Appendix H. Response to Public Comments on the Proposed Desalination Amendment and Staff Report with Substitute Environmental Documentation

Associated with the Draft [Final](#) Staff Report Including the Draft [Final](#) Substitute Environmental Documentation for the ~~Proposed~~ [Draft Final](#) Desalination Amendment

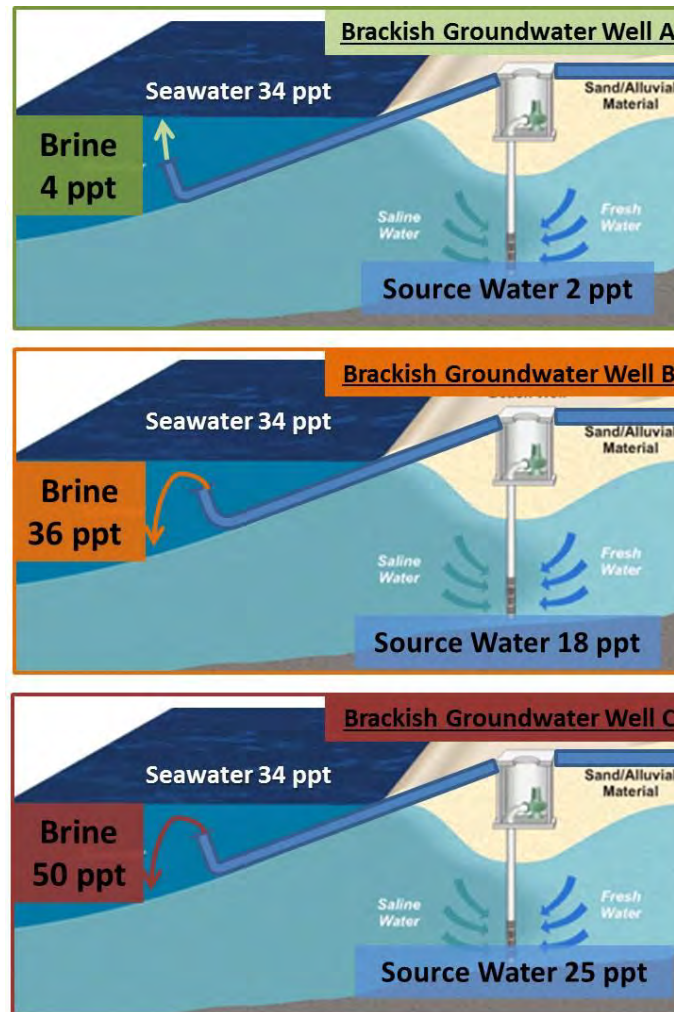
ID#	Comment Summary	Response
8.1	As a threshold matter, we are concerned that with respect to the regulation of desalination facilities, the focus of the Draft Amendments is on ocean desalination facilities and not brackish groundwater facilities.	<p>The scope of the proposed Desalination Amendment is intended to cover desalination facilities that intake seawater and discharge brine into ocean waters. In the proposed Desalination Amendment, seawater is defined as:</p> <p style="text-align: center;"><i>“salt water that is in or from the ocean. For the purposes of chapter III.L, seawater includes tidally influenced waters in coastal estuaries and lagoons and underground salt water beneath the seafloor, beach, or other contiguous land with hydrologic connectivity to the ocean.”</i></p> <p>The definition of seawater covers facilities that withdraw seawater through subsurface intakes. In some cases, the salinity of the subsurface water will vary based on environmental factors, like tidal fluctuations, which may result in the seawater periodically being brackish. Brackish water has salinity that is higher than potable water, but lower than seawater. Salinity concentrations of brackish water range from 1,000 mg/l total dissolved solids (TDS) to 25,000 mg/l TDS. (U.S. Department of the Interior Bureau of Reclamation 2014: http://www.usbr.gov/research/AWT/brackish.html)</p> <p>The scope of the proposed Desalination Amendment is not intended to include intakes from water recycling facilities and groundwater desalination facilities unless those facilities intake seawater. Additionally, brine discharges or reject water from water recycling efforts are significantly less saline than brine discharges from seawater desalination facilities and less saline than seawater, meaning they are neutrally or positively buoyant. Consequently from a salinity standpoint only, brine discharges from water recycling efforts do not pose a significant threat to water quality or other related beneficial uses of ocean waters because the salinity of the wastewater is typically far below natural background salinity of ocean water. For these reasons, brine discharges from water recycling efforts should not be covered under the scope of the proposed Desalination Amendment.</p> <p>Brackish groundwater has a wide range of salinities. By definition, brackish is a combination of fresh water and salt water and can range</p>

ID#	Comment Summary	Response
		<p>for salinity that would apply to all brackish groundwater desalination facilities in California.</p> <p>Figure 8.1-1 below presents three brackish groundwater desalination facilities with different source water and brine salinities measured in ppt. The figure illustrates how varying salinity of source water can influence the density of the discharged plume. Facility A produces a positively buoyant “brine” plume that would not affect the benthic marine environment. Facilities B and C would form dense, negatively buoyant plumes that could negatively affect the benthic marine environment if not properly discharged.</p> <p>Currently, regional water boards issue waste discharge permits (either WDRs or NPDES permits) for brackish water desalination facilities on a case-by-case basis. More research is needed to identify an appropriate statewide limitation to apply to brine discharges from brackish groundwater desalination facilities. The Staff Report with SED does not adequately study brackish groundwater desalination facilities and staff would need additional time to research the impacts associated with the facilities and incorporate the information. Furthermore we would need to meet with stakeholders in the brackish groundwater desalination facility community to solicit feedback on the proposed Desalination Amendment language. Brackish groundwater desalination facilities are currently regulated by the regional water boards on a case-by-case basis. However, if there is sufficient public interest the State Water Board may address the issue in a subsequent amendment to the Ocean Plan.</p>
